HISTORIC AND DESIGN REVIEW COMMISSION

September 04, 2019

HDRC CASE NO: 2019-479
ADDRESS: 831 BURLESON ST
LEGAL DESCRIPTION: NCB 1301 BLK 2 LOT 21 & 22
ZONING: RM-5, H
CITY COUNCIL DIST.: 2
DISTRICT: Dignowity Hill Historic District
APPLICANT: Dianet Lopez Daniel/Delafield Investments, LLC
OWNER: Delafield Investments, LLC
TYPE OF WORK: Porch modifications, side fenestration modifications
APPLICATION RECEIVED: August 16, 2019
60-DAY REVIEW: October 15, 2019
CASE MANAGER: Huy Pham

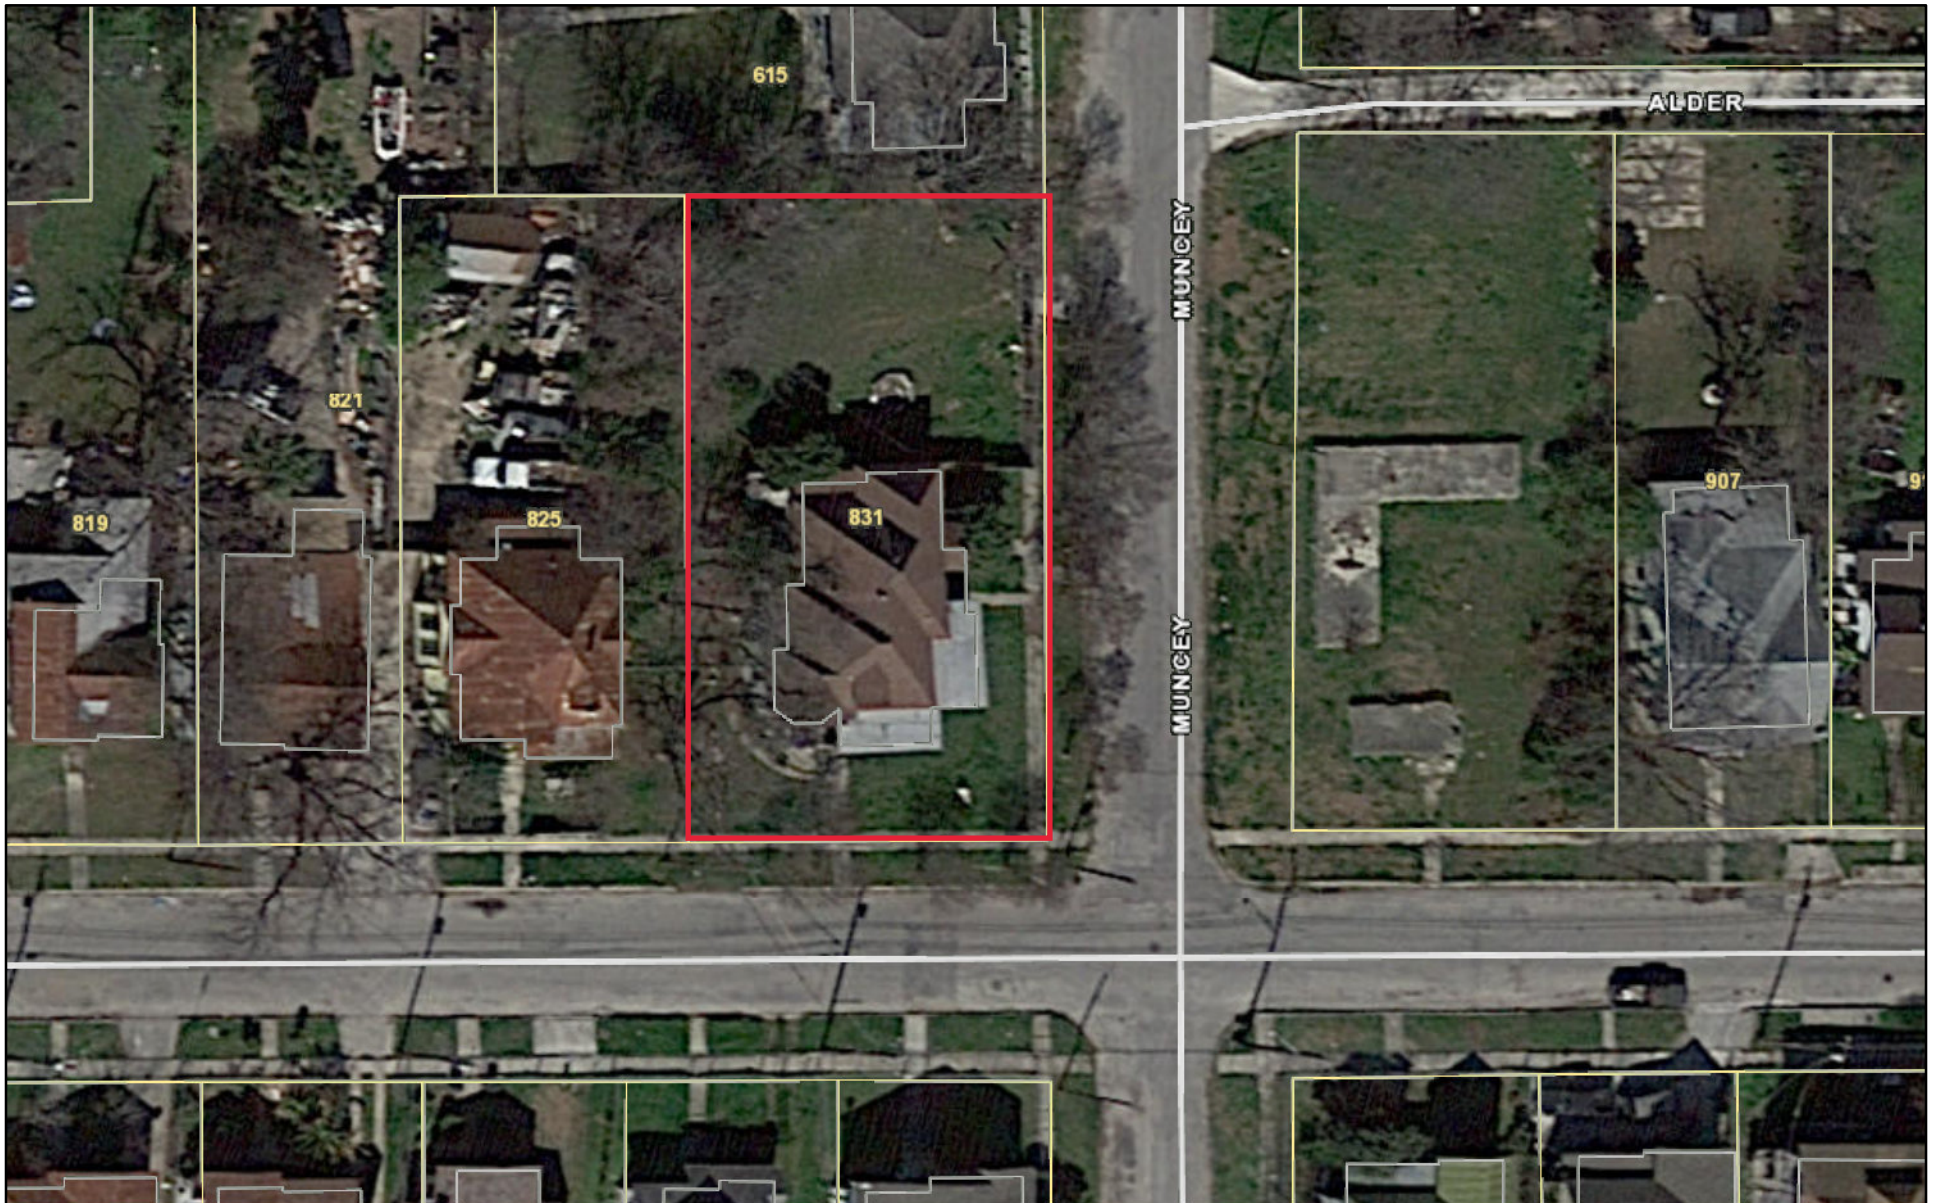
- b. FRONT PORCH – The applicant has proposed to extend the existing modified front porch to meet the corner of the side addition to feature a rounded footprint referencing the original rounded wraparound porch. Per the

Guidelines for Exterior Modifications and Alterations 7.B.v. porches, balconies, and porte-cocheres should be reconstructed based on accurate evidence of the original, such as photographs; if no such evidence exists, the design should be based on the architectural style of the building and historic patterns. Staff finds that the proposed front porch modifications per the submitted drawings are generally consistent with the Guidelines.

LEFT SIDE ELEVATION

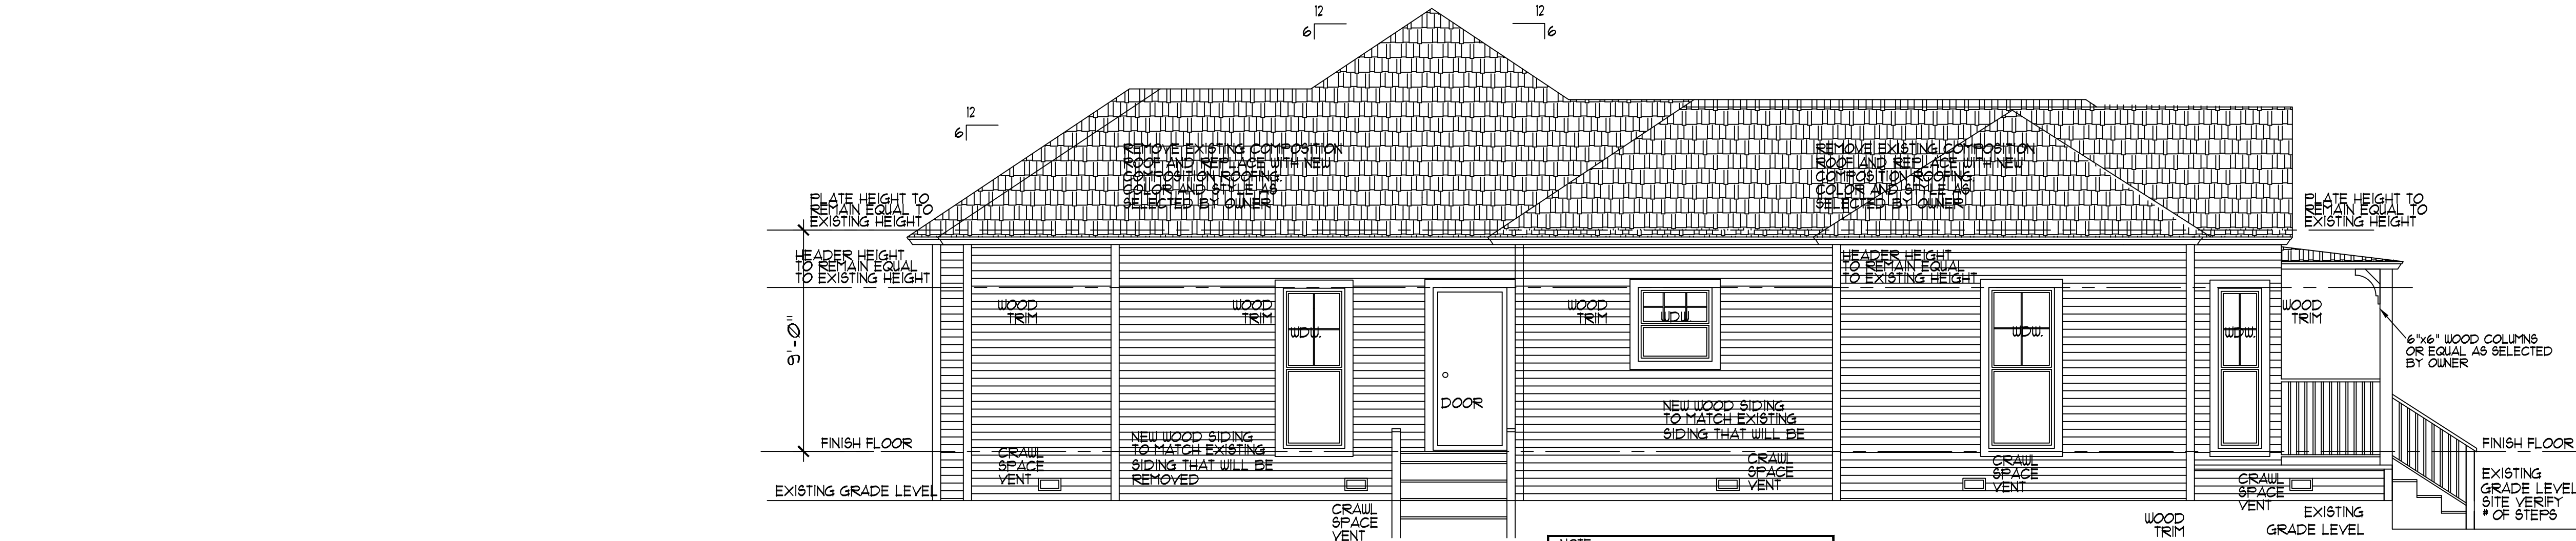
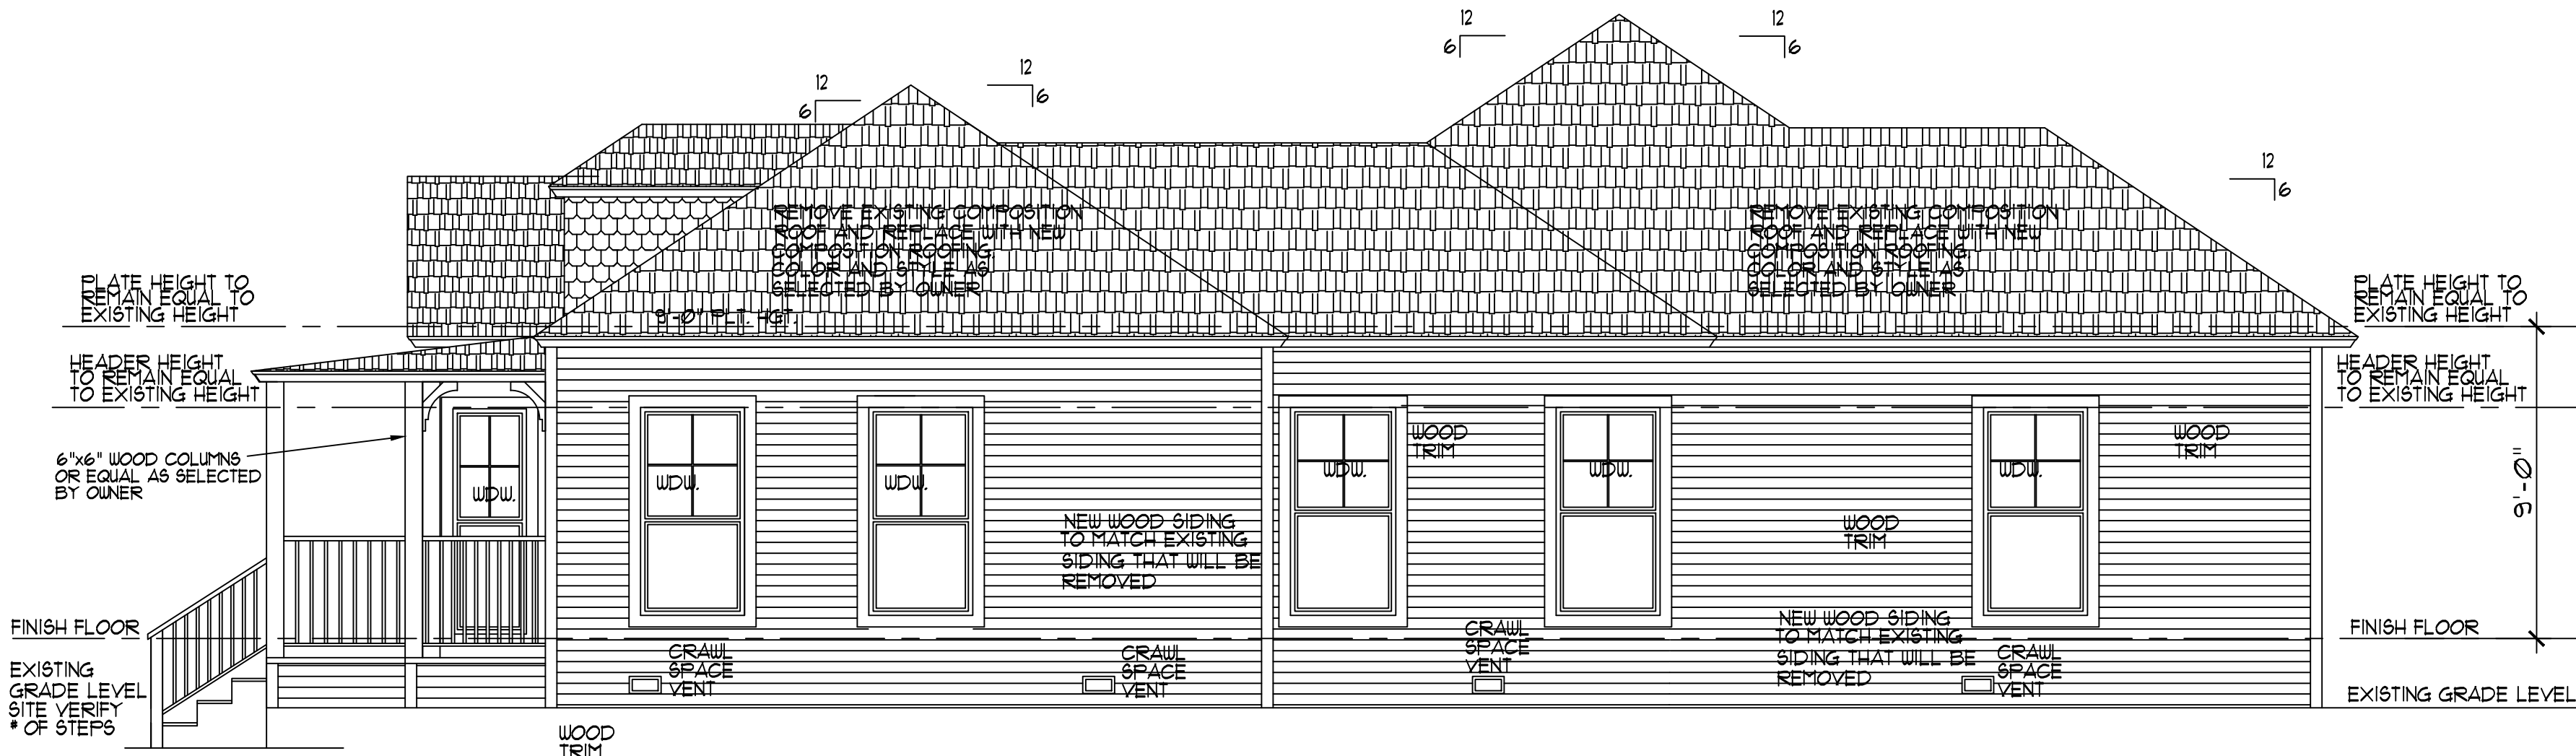
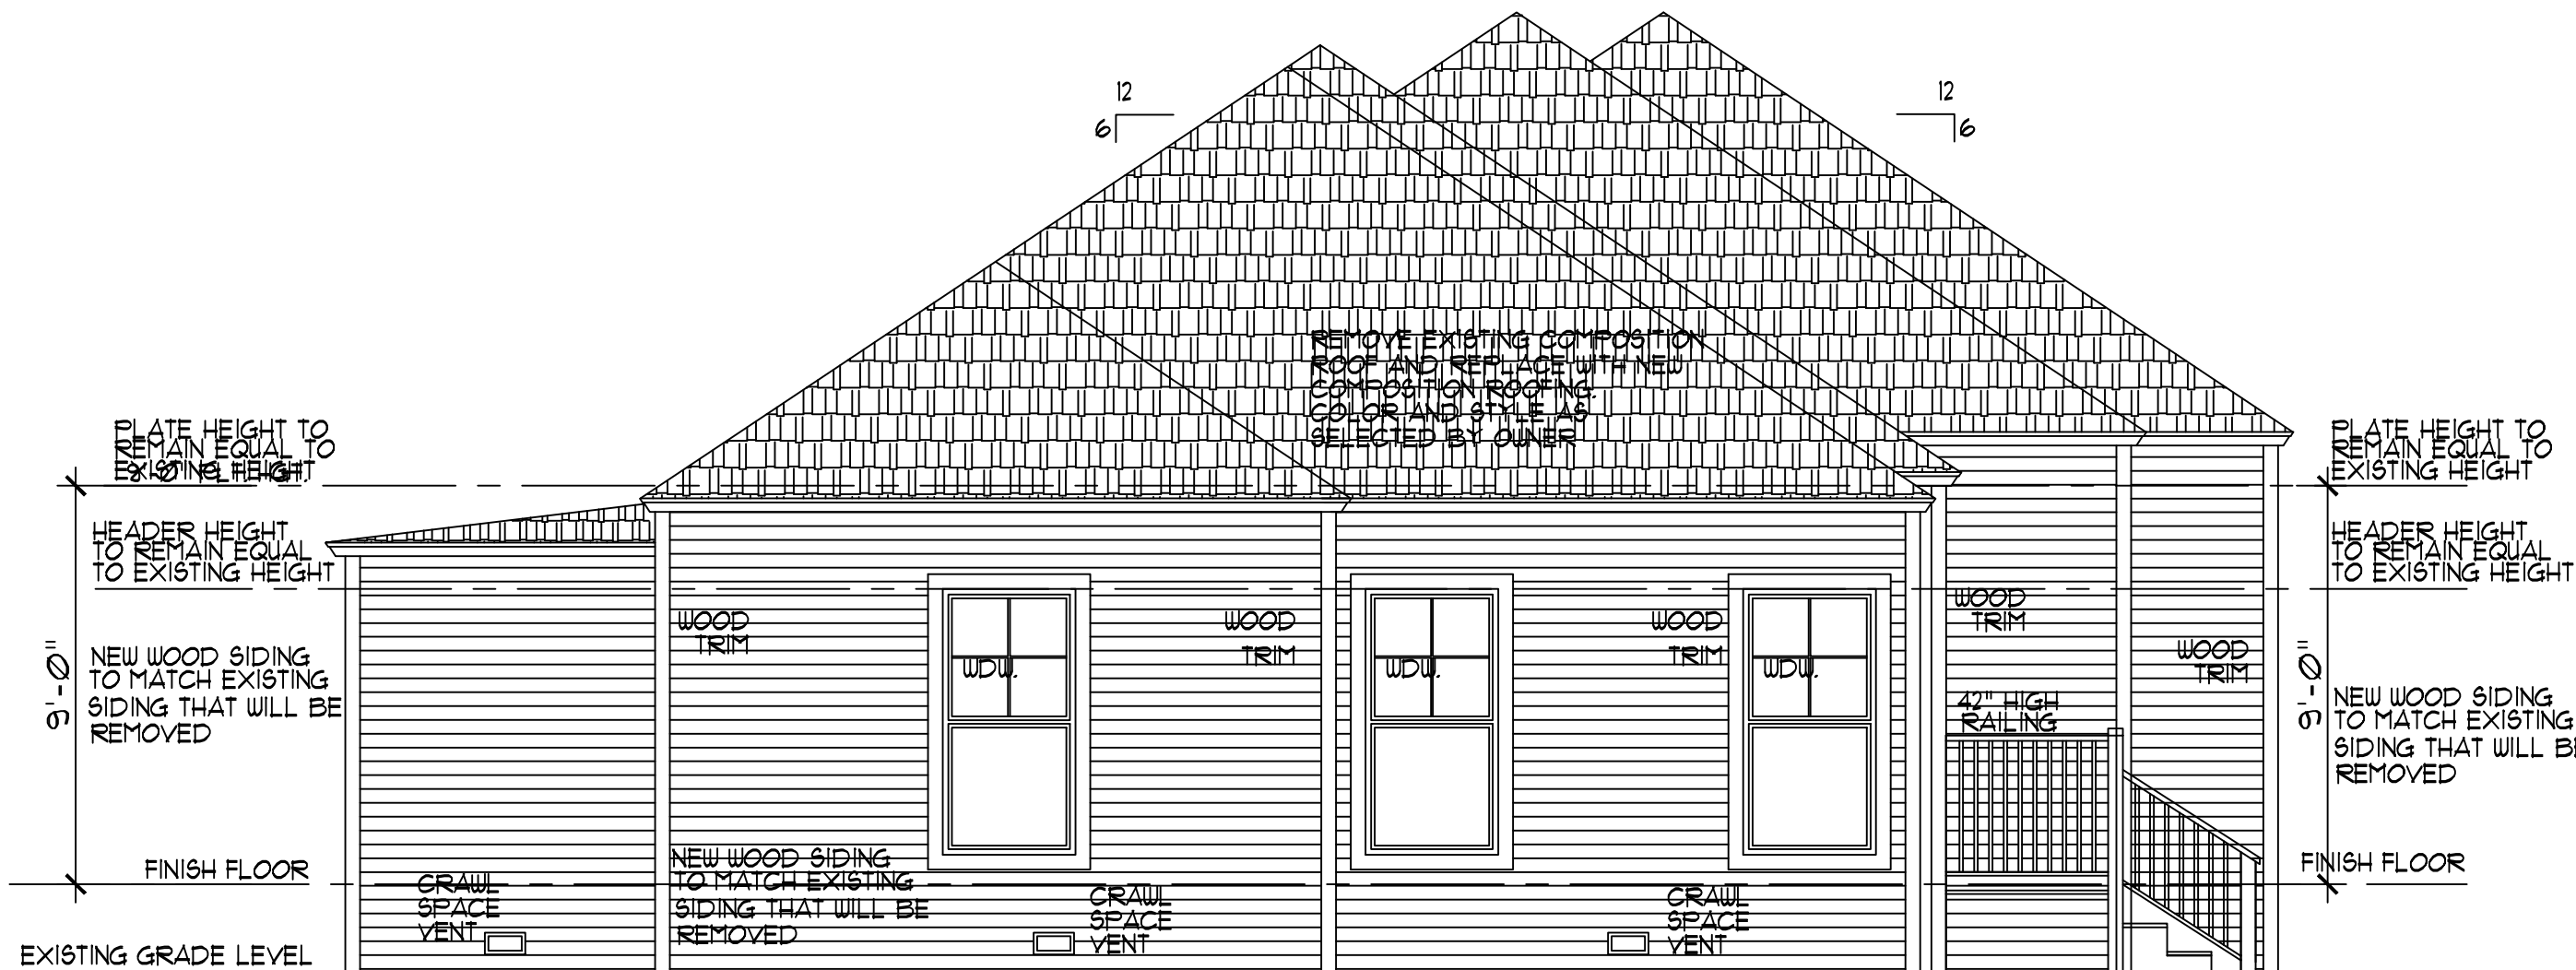
- c. WEST SIDE FENESTRATION – On the rear of the west side, the applicant has proposed to remove to ganged wood windows and doorway to install a new side door. From front to rear, the existing side fenestration features the two ganged wood windows, an isolated wood window, and then a wood door with steps. Staff is in concurrence with the Design Review Committee members and finds that the two ganged windows were likely not original to the house and their modifications may be appropriate provided a comparable fenestration pattern is installed. The isolated wood window is likely original and should be restored in-place. The new side door should feature a matching frame and a simple 6-panel configuration or a style that relates to the historic structure.

- i. That the new side door feature a matching frame and a simple 6-panel configuration or a style that relates to the historic structure
- ii. A site plan with the proposed fence line should be submitted to staff prior to final approval.

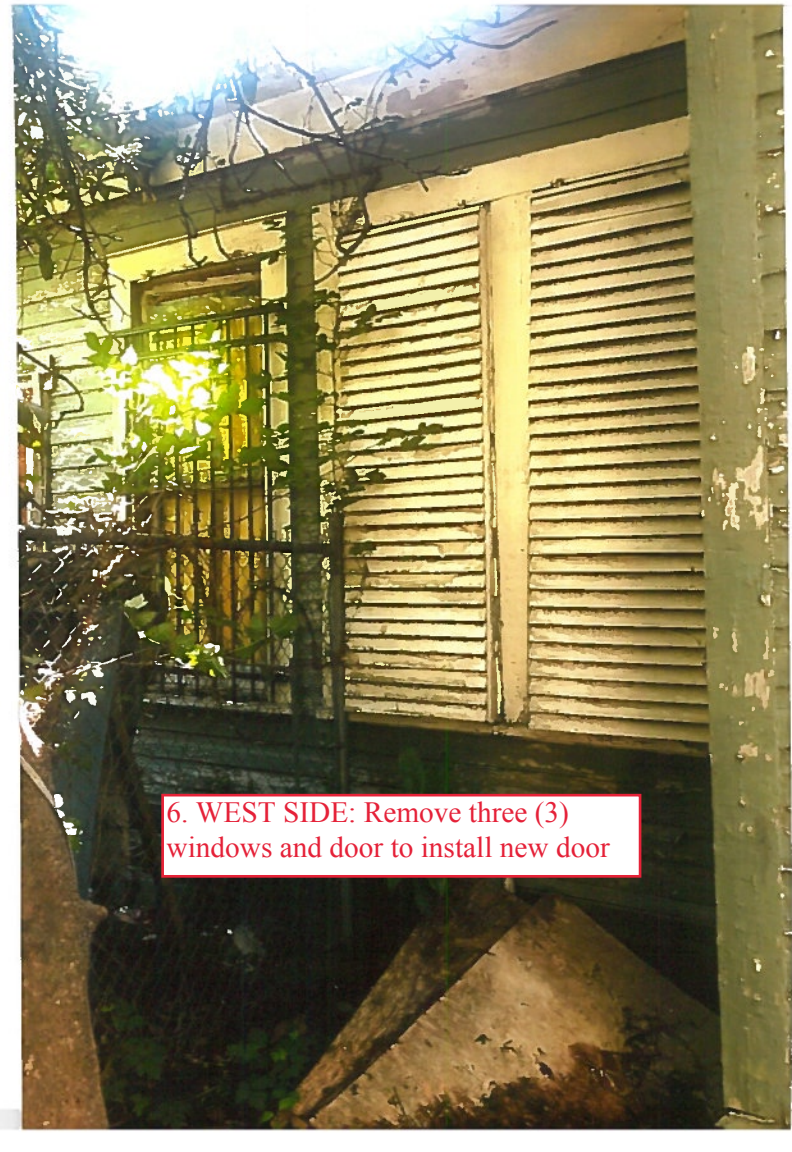
4. WEST SIDE: Remove non-historic side door and corner window
5. WEST SIDE: Modify existing square window for interior kitchen

4. WEST SIDE: Remove non-historic side door and corner window
5. WEST SIDE: Modify existing square window for interior kitchen
